DRAFT REPORT

Dam Safety Assessment of CCW Impoundments

Sikeston Power Station

May 27, 2010

Photo 1 – Outlet structure. Note bent gate operator stems.

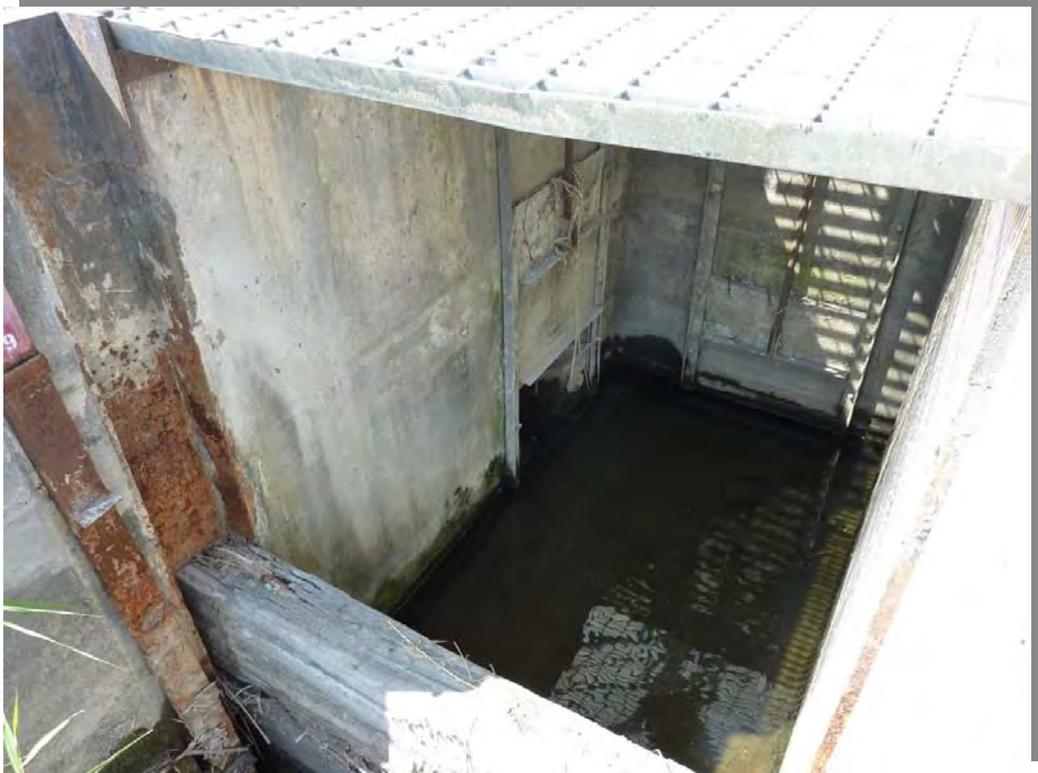
- Water exits the pond through a concrete weir structure near the northwestern corner of the impoundment. The structure allows for discharge into the Process Waste Pond (normal condition) or directly out to West Westfield Avenue. The operators for the Outlet Structure's slide gates are bent and appear to be inoperable (Appendix C – Photos 1 - 3).

- The drainage ditch that runs along the outboard toe was not constructed with an adequate slope to properly drain stormwater runoff.
- A more significant wet area was observed at the outboard toe near the outlet structure.
- The outlet structures slide gate operator stems are bent and appear to be inoperable.

- Inboard slopes – keep vegetation under control to allow for visual inspection of the exposed portion of the slope above the waterline.
- Repair or replace the slide gate operator stems.
